ACS-2 PUIS Update to Power Management States

March 2, 2009

Revision 2

Revision History		
Rev	Date	Description
0	April 12, 2008	1) Initial Revision
1	January 30, 2009	1) Converted nested conditions to a table
2	March 2, 2009	1) Removed the table of PM2 state transitions 2) Added 3 new PUIS-related states to the state diagram, and associated text.

Figure 1 — Power Management State Diagram

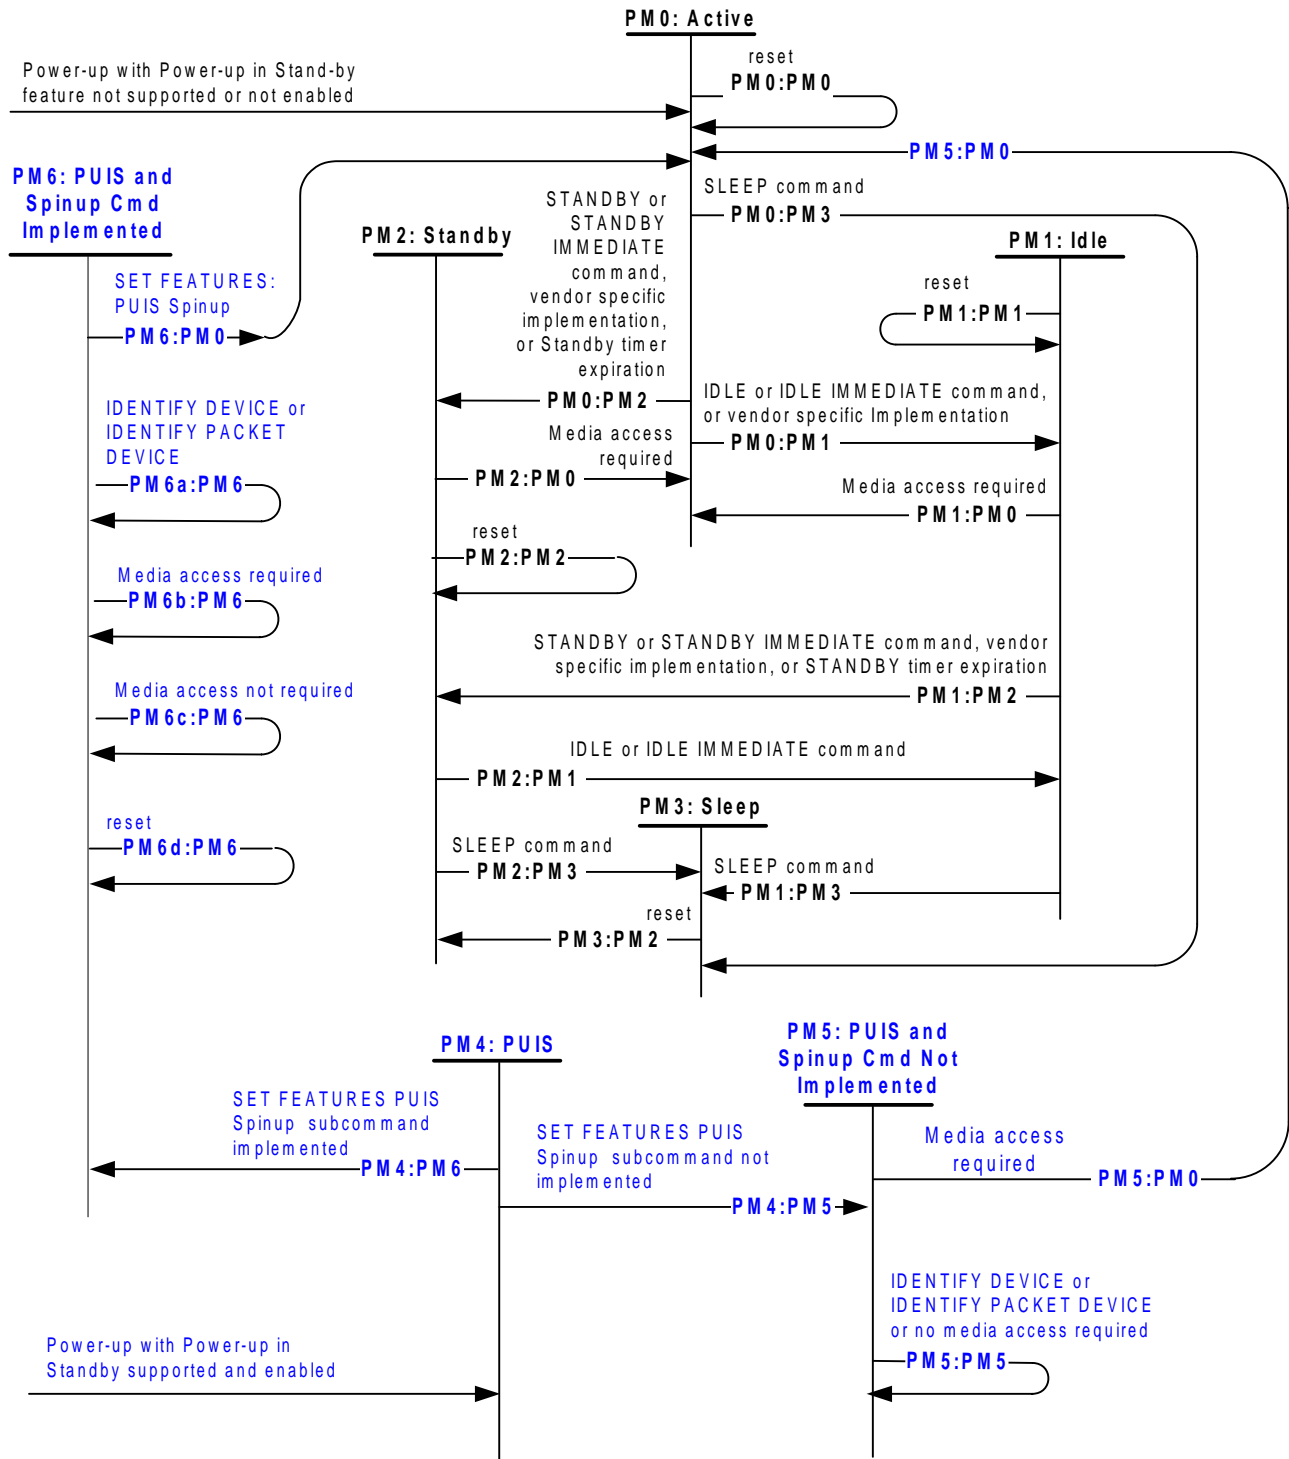
PM0:Active: This state shall be entered when the device receives a media access command while in Idle or Standby mode. This state shall also be entered ~~after processing a power-on reset if when the device is powered-up with~~ the Power-Up In Standby feature is not ~~supported implemented~~ or ~~is~~ not enabled (see 4.2).

~~If the PUIS feature set is enabled, then:~~

- h) ~~if the device implements the optional SET FEATURES PUIS feature set device spin-up command, then~~
 - A) ~~if the a SET FEATURES PUIS feature set device spin-up command is received, then the device shall transition to the PM0:Active state; or~~
 - B) ~~if the a SET FEATURES PUIS feature set device spin-up command has been processed then:~~
 - a) ~~if media access is required, then the device shall transition to the PM0:Active state.~~

PM4:PUIS: This state shall be entered when after processing a power-on reset if the PUIS feature set is supported and is enabled.

Transition PM4:PM5: A device shall transition to the PM5:PUIS No Spinup Implemented state if the device does not implement the optional SET FEATURES PUIS feature set device spin-up command (see [editors note: 7.52.8 in ACS-2]).

Transition PM4:PM6: A device shall transition to the PM6:PUIS Spinup Implemented state if the device implements the optional SET FEATURES PUIS feature set device spin-up command.

PM5:PUIS No Spinup Implemented: This state shall be entered when after processing a power-on reset if the PUIS feature set is supported and is enabled and the device does not implement the optional SET FEATURES PUIS feature set device spin-up command.

PM4:PUIS Spinup Implemented: This state shall be entered when after processing a power-on reset if the PUIS feature set is supported and is enabled and the device implements the optional SET FEATURES PUIS feature set device spin-up command.
